Newport City Council – Planning Consultation

Application Number: 25/1056

Proposal: REPLACEMENT OF THE DEMOLISHED DWELLING "BRAMLEY"

Arboricultural Remarks.

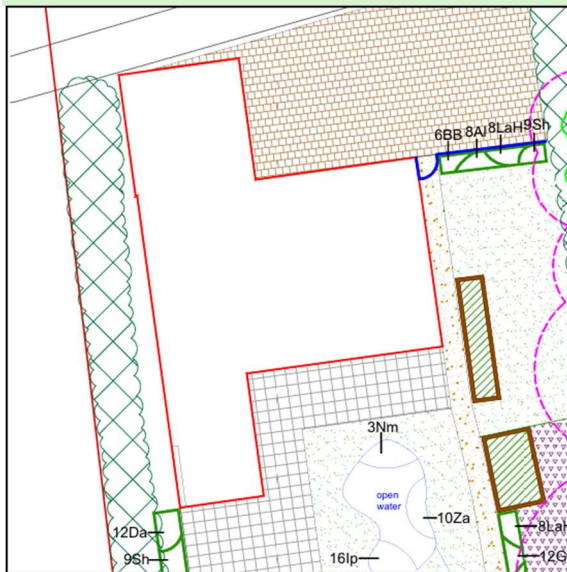
The Tree Survey and Arboricultural Implications Assessment Rev B shows the new dwelling outside of H1's Root Protection Area and this is welcomed and the previous objection removed (refer to plan excerpt below).

However, it is noted that there is disparity between the house location on the Landscape Plan where it is still shown as impacting on H1 (refer to plan excerpt below). This should be revised to match the Tree Protection Plan .

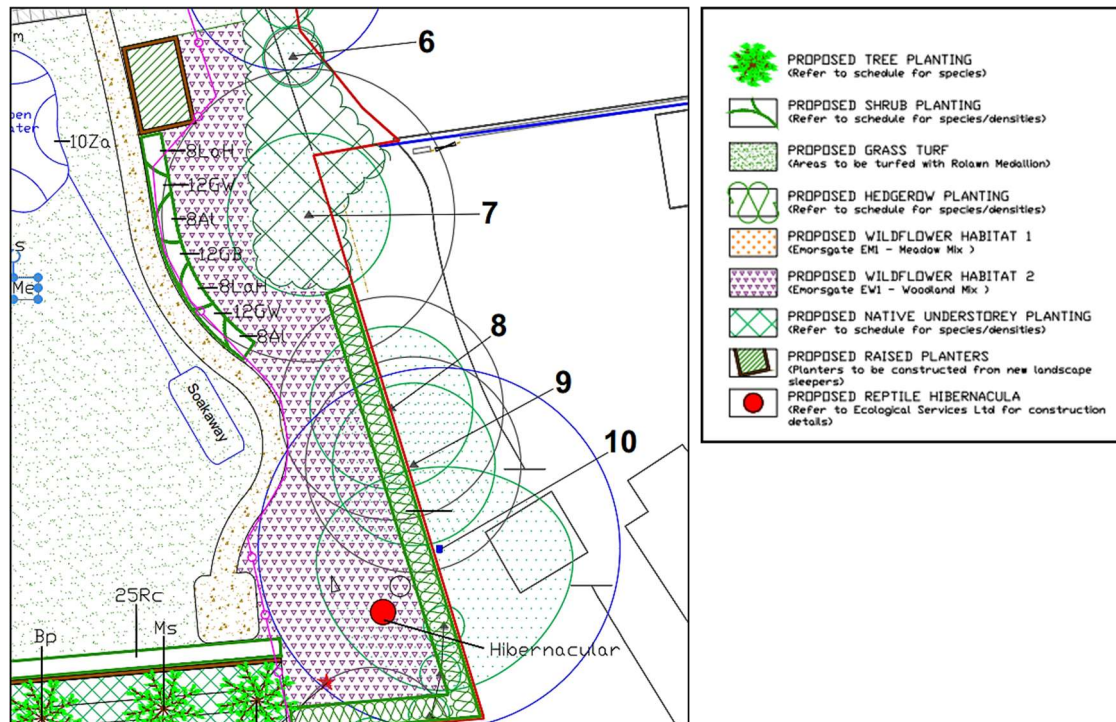
June 2026 – whilst the landscape detail has been provided in the updated Tree Protection Plan, it is noted that there is significant landscape planting within the Root Protection Area of retained trees and this, in principle, is not acceptable, due to the related root damage and competition with existing trees (refer to plan excerpt below). **An objection remains on arboricultural grounds.**

In addition, it is noted that seeding and turfing is proposed in the Root Protection Area of retained trees and ideally this should be avoided, however if it is regarded as important then these operations will need to be considered within an **Arboricultural Method Statement**, which can be conditioned.
